Subject: DETROIT™ Reman Built HDEP Engines - Incorrect Gear Train Bolt Torque
Models Affected: Certain DETROIT™ Reman Built HDEP Engines

Daimler Trucks North America LLC, on behalf of its DETROIT™ Powertrain Division, is initiating Field Service Campaign D20M6 to modify the vehicles mentioned above.

Subject: **Field Service Campaign D20M6**

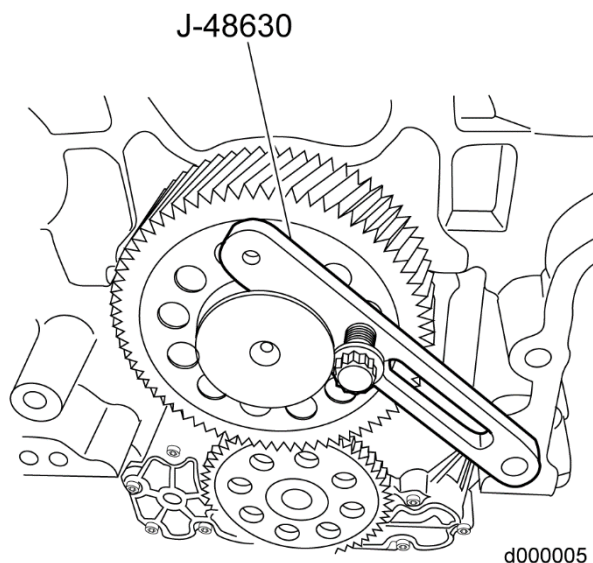
1. Shut off the engine, apply the parking brake, chock the wheels, and perform any other applicable safety steps.

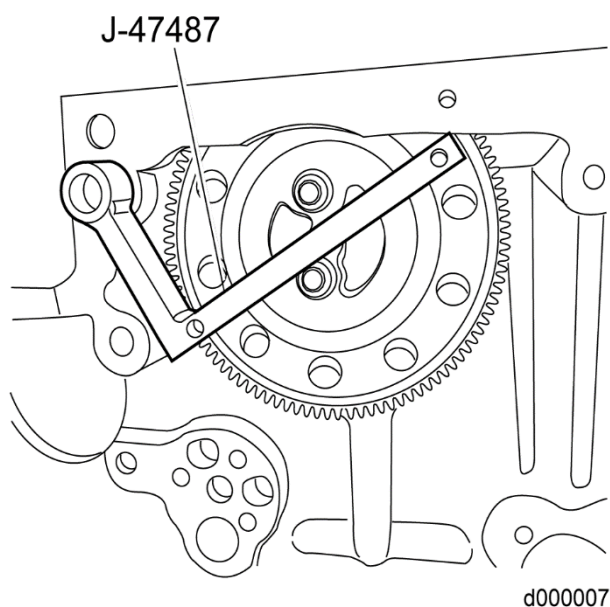
2. Disconnect the batteries. Refer to the Original Equipment Manufacturer (OEM) procedure.
3. Open the hood.
4. Remove the flywheel housing. Refer to section "Removal of the Flywheel Housing"
5. Rotate the crankshaft so the pistons in cylinders 1 and 6 are at Top Dead Center (TDC), if not already positioned. The locating pin for the crankshaft gear should be at the 12 o'clock position.
6. Install and lock crankshaft TDC locating tool (J-48630) into place with a flywheel mounting bolt. See figure below.
